Determination 2010/037

Safety barrier to a carparking area at 16 Windy Ridge, Glenfield

Figure 1: the relevant detail as shown on the building consent plans

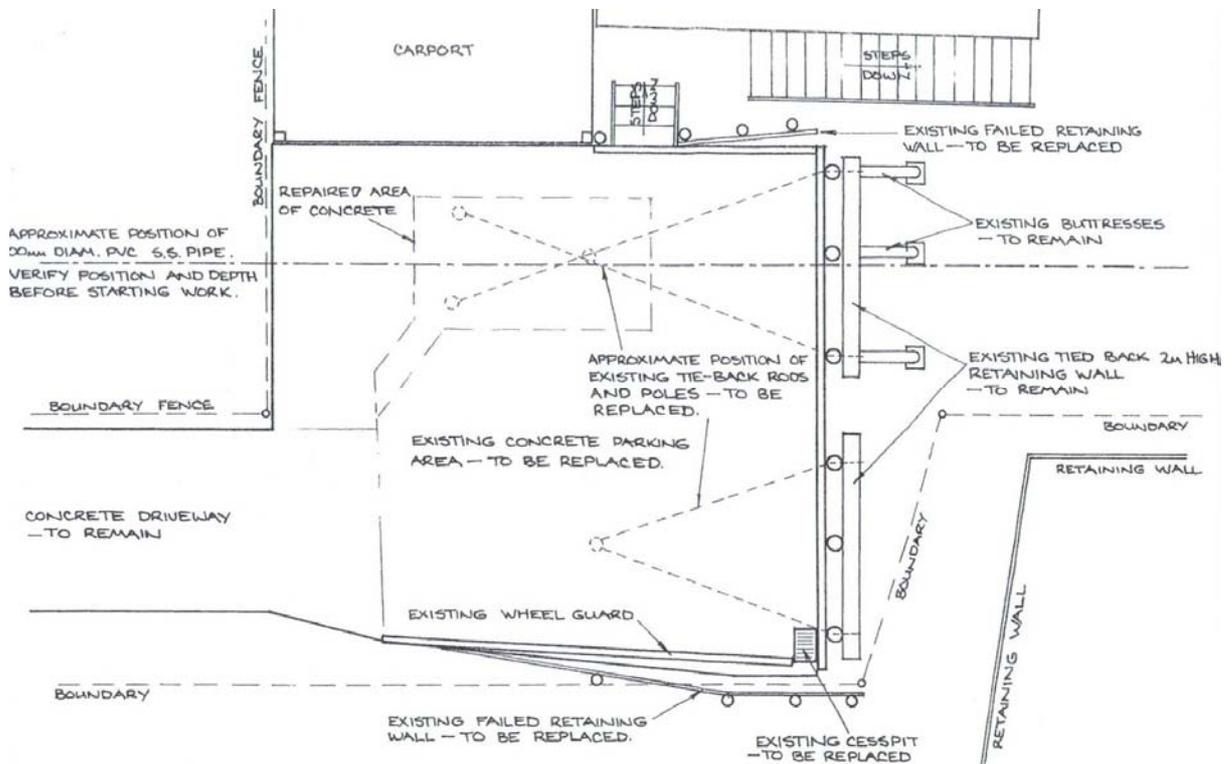
- 2.3 The authority wrote to the consulting engineers on 18 November 2008 about the consent application. With regard to the proposed barriers, the authority noted that the proposed retaining wall would extend 1.4 metres above the existing ground level. An authority’s officer confirmed that :

- ...pursuant to parts F4/AS1 (safety from falling) and B1/AS2 (handrail requirement) of the New Zealand Building Code a building consent for the proposed 1.1 metres high balustrade is required at this stage. Please provide revised plans that incorporate the proposed balustrade into the current application.

- 2.7 Following an inspection of the building work by an officer of the authority, the officer noted in a memorandum dated 24 June 2009 that:
- 1.0M high barrier will be required to replace R/T walls with threaded SS rod and washers 50 x 50 to the vertical balustrade posts – Engineer to Design. No toe hold between 150 and 760 – max gap 15mm for horizontal palings and 100 for vert.

- 2.10 In an email to the consulting engineers dated 9 October 2009, the authority stated that it would not be possible to complete the work in two stages as the work completed in each stage must comply with the Building Code. In this case, the code requirement was in respect of Clause F4. It was also noted that the building consent as issued did not mention any stages and that the work in its current state may be dangerous if left without a barrier.

- 2.11 In an email to the consulting engineers dated 25 November 2009, the authority noted that the consent plans showed how the balustrade was to be constructed, so should be installed under the current building consent. It was accepted that the plans noted that the balustrade was to be included under a stage 2 consent, and this in itself was not a real issue as long as the next consent followed immediately after the first consent. Both consents would then be signed off at the same time in one code compliance certificate.

- 5.8 Based on these facts, I am of the opinion that in terms of section 112, there was no need to provide barriers to the perimeter of the car pad as regards the issuing of the building consent in question. Accordingly, I find that the building consent was

correctly issued and that the authority should issue a code compliance certificate in line with that consent without the necessity to install protective barriers.
